WATER PERMIT NO. 6110-3

Name of Applicant: Dakota Dunes Community Improvement District

REPORT FOR
WATER PERMIT APPLICATION NO. 6110-3
DAKOTA DUNES COMMUNITY IMPROVEMENT DISTRICT
DECEMBER 7, 1998

**RECOMMENDATION OF CHIEF ENGINEER FOR WATER PERMIT
APPLICATION NO. 6110-3, Dakota Dunes Community Improvement District**

ATTACHMENT TO FORM TWO
APPLICATION FOR
WATER PERMIT FOR IRRIGATION

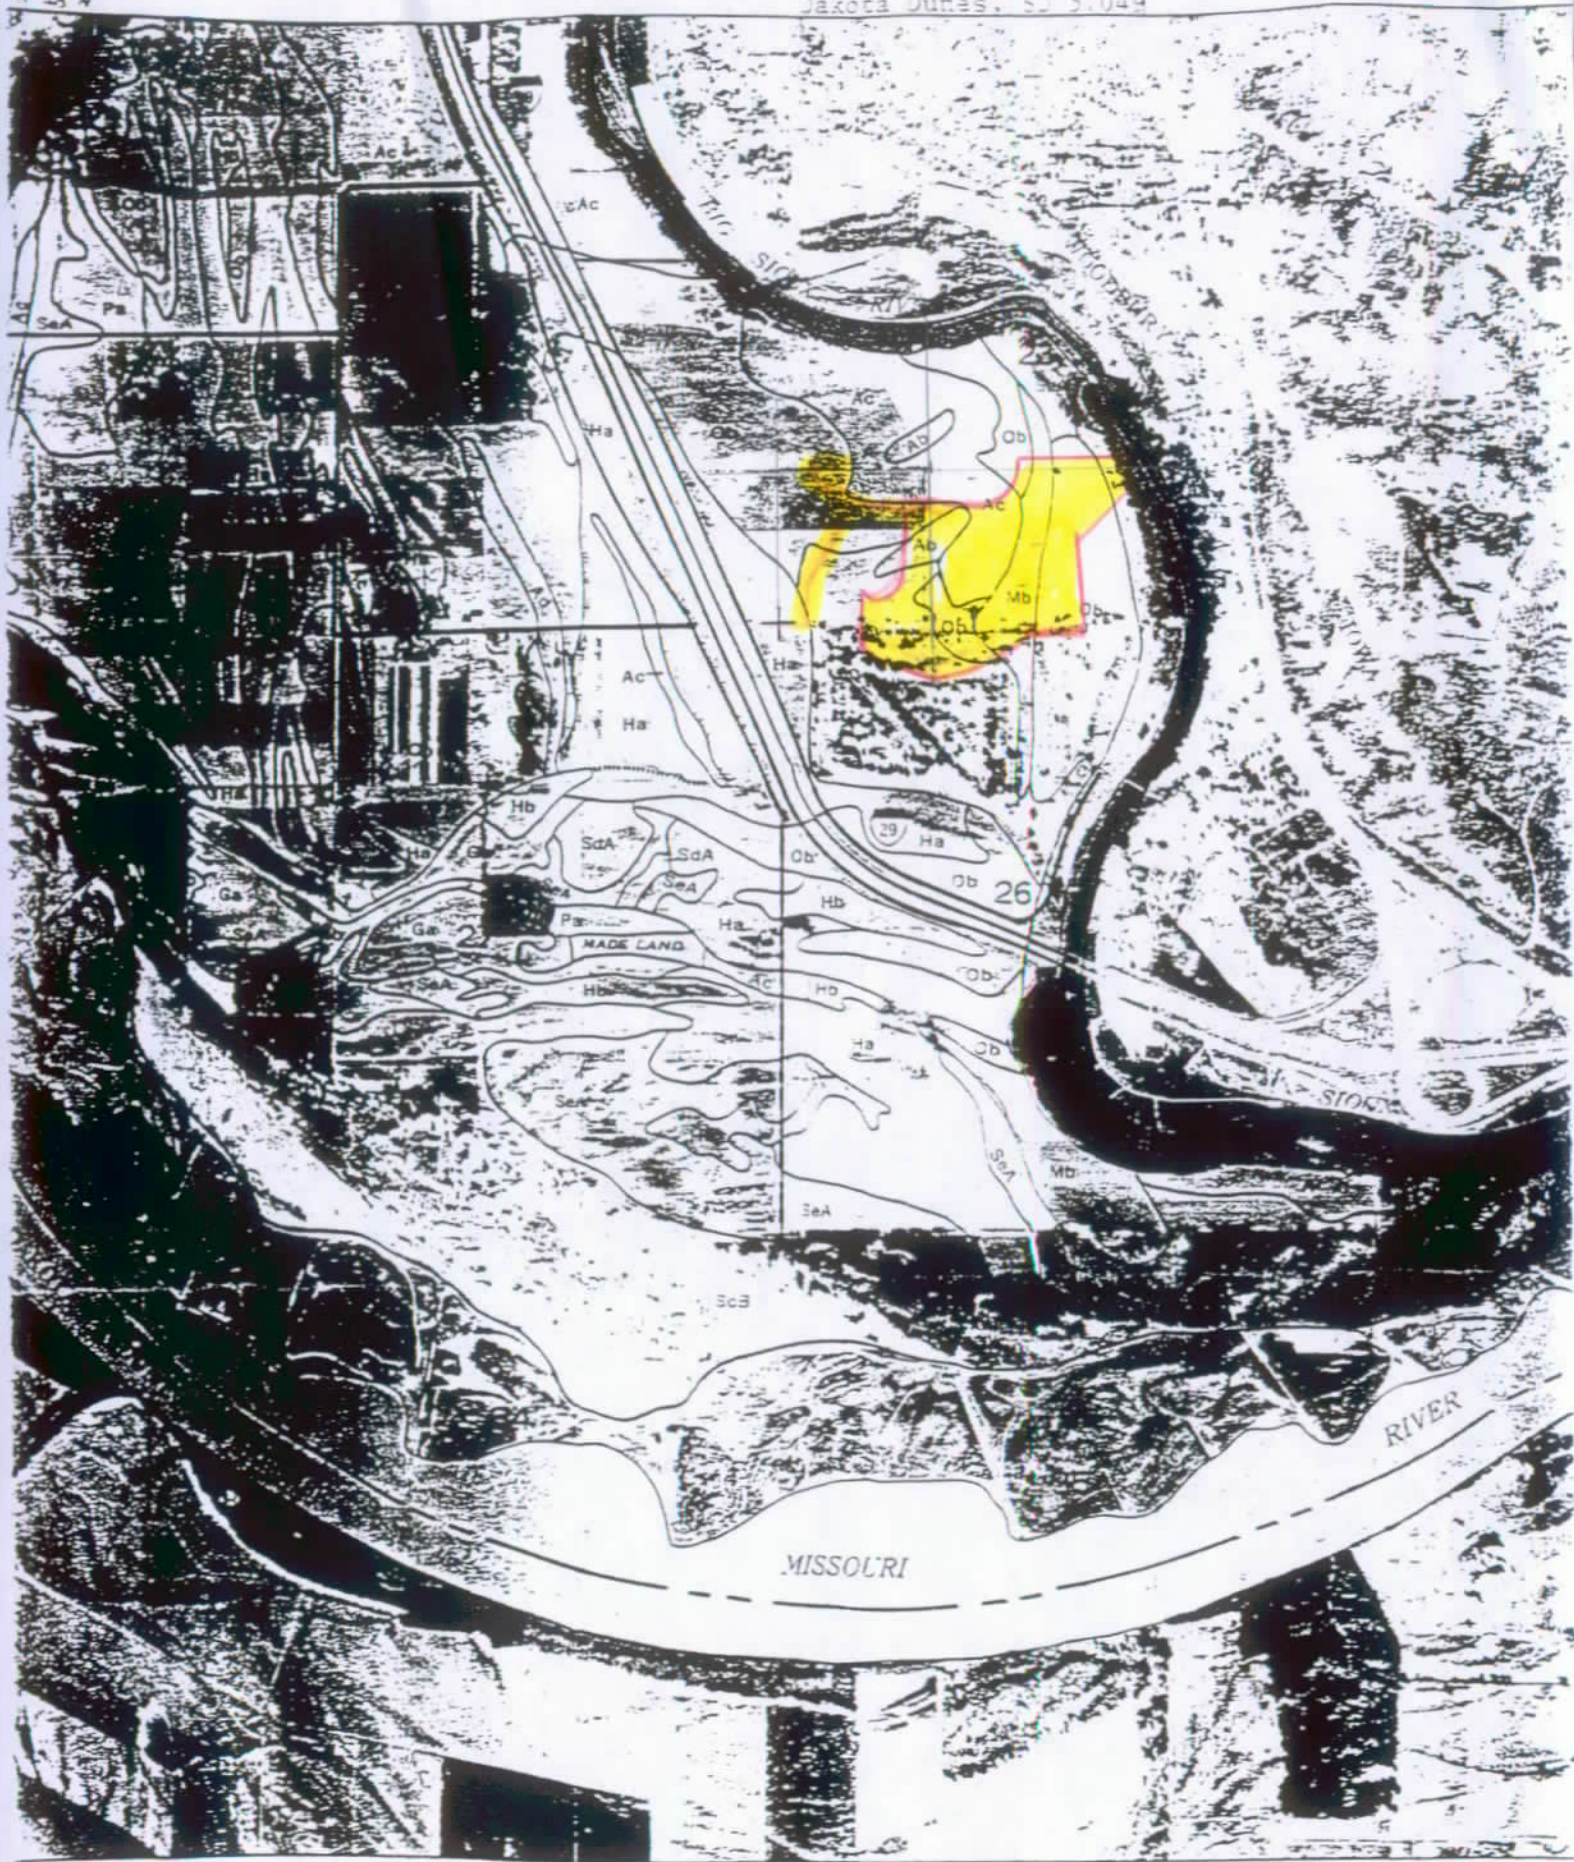
Enclosed are the maps and application as submitted. The land description and number of acres, as listed on Item No. 7 of the application, needs to match the area to be irrigated, as outlined on the map. The plat map does not outline the area to be irrigated. The soils map outlines the area of irrigation, but appears to include lands in Section 22 and 26. Please make the necessary adjustments on the application and/or the maps, preferably the plat map which shows the well location and has the required signature.

I explained what was required on the map. Outline lands to be irrigated and include any additional lands that would be located in Section 26. The lands in Section 26 would have to be added to Item No. 7 also.

The lakes on the map do exist and are actually the borrow pits from when the interchange was constructed. The map shows three lakes but only two of the lakes are used as part of the planned irrigation system. The smaller lake to the west is not used as part of this application. The lakes do receive surface run-off and in general that maintains the lakes but with making irrigation withdrawal they will need to supplement the lakes with well water. The two lakes are connected to one another.

Please find the enclosed revised "Application for Permit to Appropriate Water for Irrigation" along with the revised attachment to Form 2 - Application for Irrigation in South Dakota and the revised soil map.

As we discussed Monday, I am writing to provide additional information on the subject application. The requested water right is to pump at a rate of 1,000 gpm from a well into the north lake which has an estimated surface area of approximately 135,000 square feet. Assuming an average depth of 15 feet, the approximated volume of the north lake is 46.5 acre-feet. Water flows from the north lake under Stevens Port Drive to the south lake, which has an estimated surface area of 173,000 square feet. Assuming an average depth of 15 feet, the approximate volume of the north lake is 59.8 acre-feet. The irrigation system will be served by pump stations in the south lake with a combined capacity of 840 gpm.
